Project	IEEE 802.16 Broadband Wireless Access Working Group < http://ieee802.org/16 >	
Title	Addressing the missing MAC functions in 16m Relay (Section 15.6)	
Date Submitted	2009-11-06	
Source(s)	Rakesh Taori, Jicheol Lee, Heewon Kang, Hokyu Choi, Hyunjeong Kang, Jungshin Park, Jack Jang, Youngkyo Baek, Jung Je Son, MingXia Xu Samsung Electronics Company, 416, Maetan-3 dong, Yeongtong Gu Suwon, South Korea. 443-742.	Contact rakesh.taori@samsung.com jicheol.lee@samsung.com hkang@samsung.com
Re:		
Abstract	This document analyzes the different solutions that are possible for relay. The document argues that whether a function should be located in the ARS or the ABS should be decided on the basis of performance (overhead, latency).	
Purpose		
Notice	<i>This document does not represent the agreed views of the IEEE 802.16 Working Group or any of its subgroups. It represents only the views of the participants listed in the "Source(s)" field above. It is offered as a basis for discussion. It is not binding on the contributor(s), who reserve(s) the right to add, amend or withdraw material contained herein.</i>

Addressing the missing MAC functions in 16m Relay (Section 15.6)

Figure xxx – Call flow for idle mode entry in the relay cell

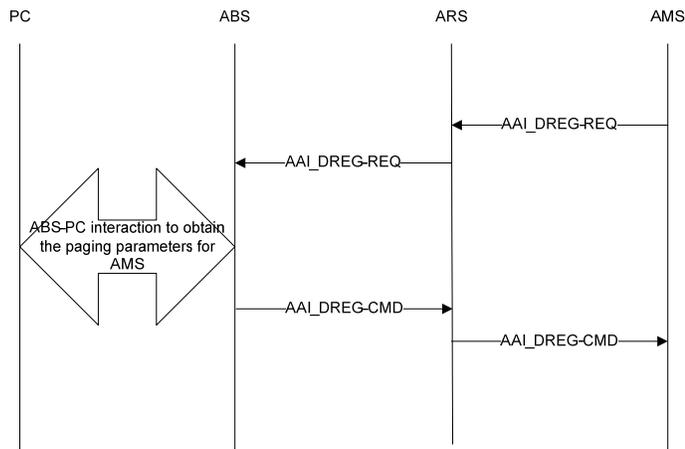
If the idle mode functions are managed at the ABS, the access ARS shall relay the AAI_DREG-REQ/CMD message between the ABS and the AMS. An operation of idle mode entry with an ARS involved is shown in Figure xxx.
